# Illinois Department of Transportation

SUBJECT: FAP Route 332  
Project NHF-0332(075)  
Section (48X-2)BR-2  
Vermilion County  
Item No. 15, 01/21/05 Letting  
Addendum A

## NOTICE TO PROSPECTIVE BIDDERS:

FAP Route 332 (IL Route 1)  
 Section (48X-2)BR-2  
 Vermilion County

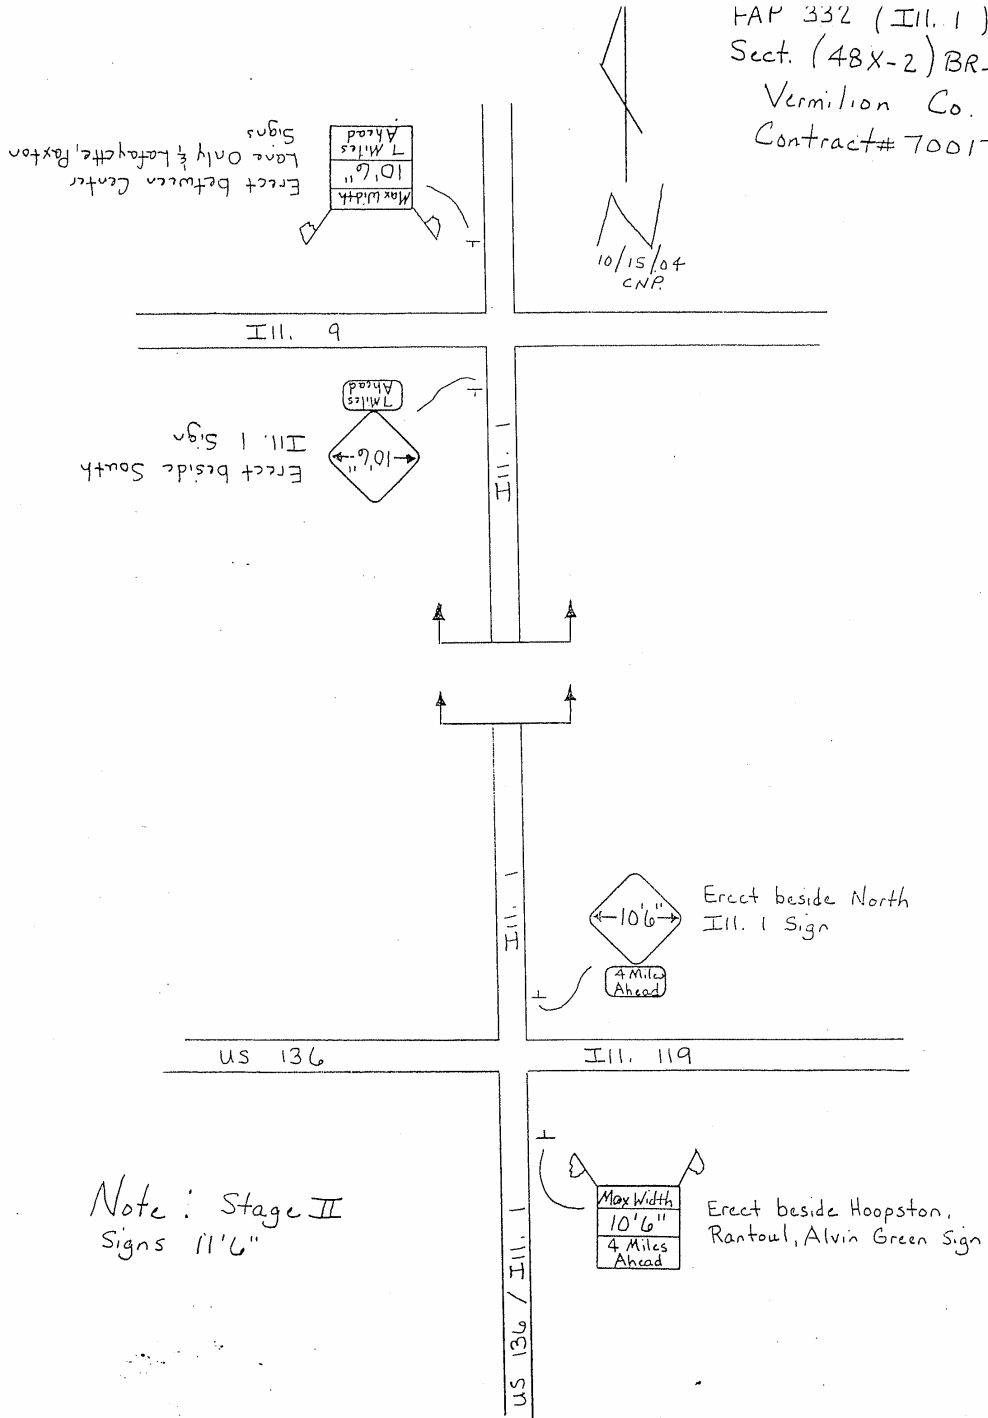
The work within this contract will cause a width restriction requiring "maximum width" signing. The Bureau of Operations will provide all "maximum width" signs to be erected at locations shown within the plans. The Traffic Operations Engineer shall be given two weeks notice prior to the start of the project in order to fabricate the signs. The contractor shall be responsible for picking up the signs at the District Office, erecting the signs at the designated locations, maintaining the signs during the course of the work, removing the signs upon completion of the work, and delivering the signs back to the District Office in an acceptable condition. The Contractor will be responsible for replacing any sign that the Engineer determines has been damaged beyond normal wear. The Engineer shall be the sole judge of damage and normal wear.

All width restrictions shall be removed from the roadway(s) during the "winter period", defined as being from December 1 of one year through march 31 of the succeeding year. If width restrictions are not removed during this time, the Contractor shall be liable to the Department for liquidated damages per calendar day, and based upon the full Original contract Amount according to Article 108.09.

Note: Stage II  
 Signs 11'6"
